**PITTSBURG UNIFIED SCHOOL DISTRICT
HIGHLANDS ELEMENTARY SCHOOL
PORTABLES REPLACEMENT PROJECT**

**BID ADDENDUM NO. 3
May 5, 2026**

PROJECT: Highlands Elementary School – Portables Replacement
4141 Harbor St, Pittsburg, CA 94565

E7.02

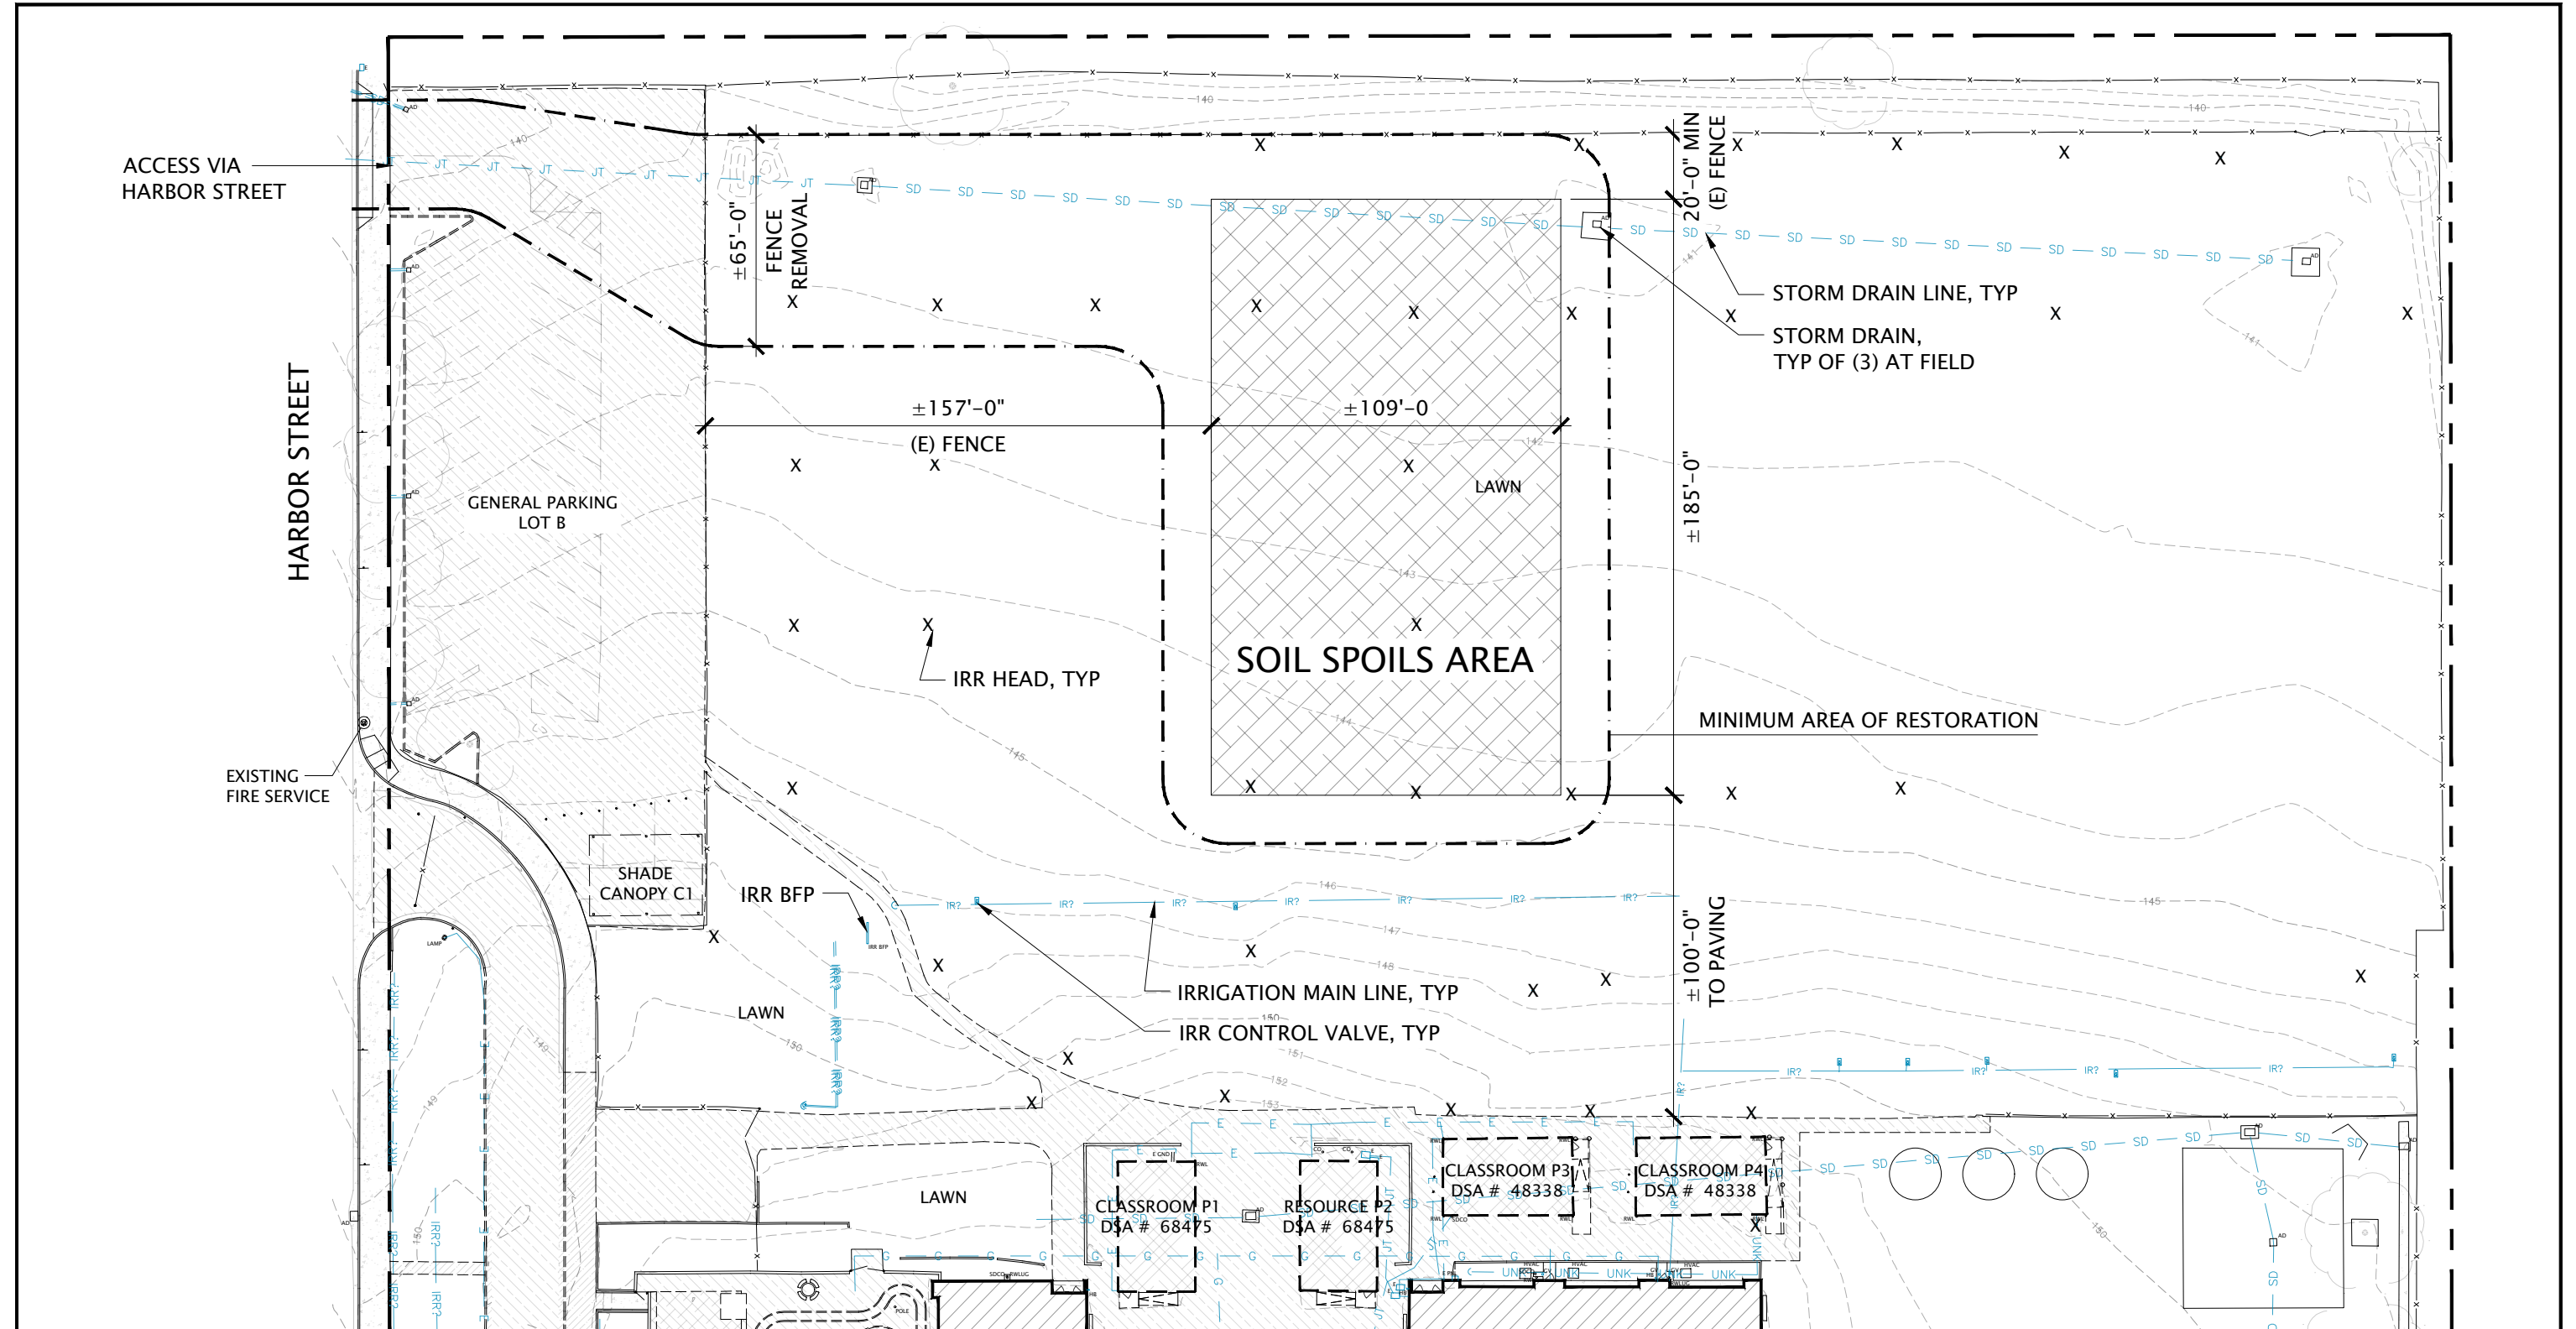
Description: 1. Revise Detail 2/E7.02 "Pole Base in Planters" as shown on the attached E5.01.

IRSK-01

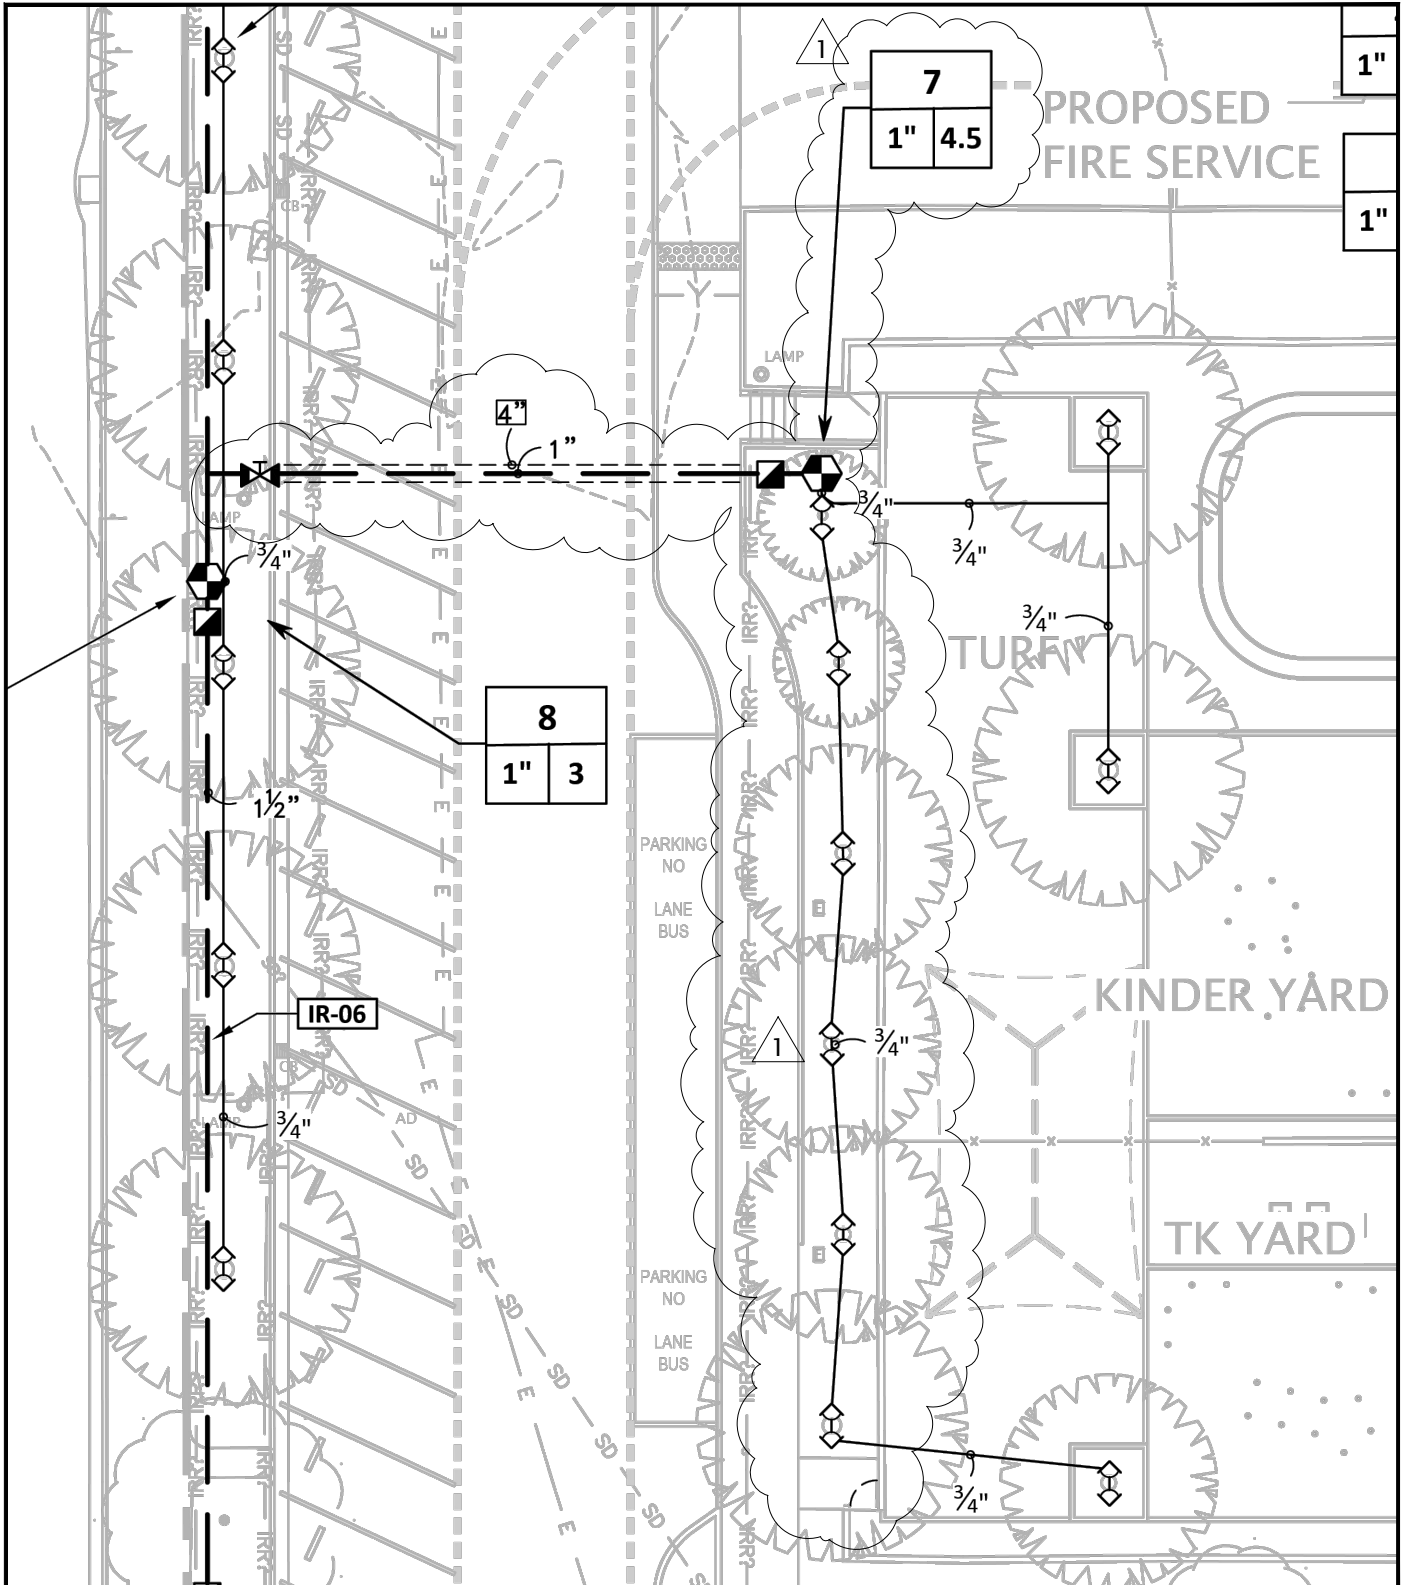
Description: 1. Add irrigation replacement, regrading, 6" of topsoil and hydro-turf replacement at area of stockpile soil spoils and as shown in IRSK-01.
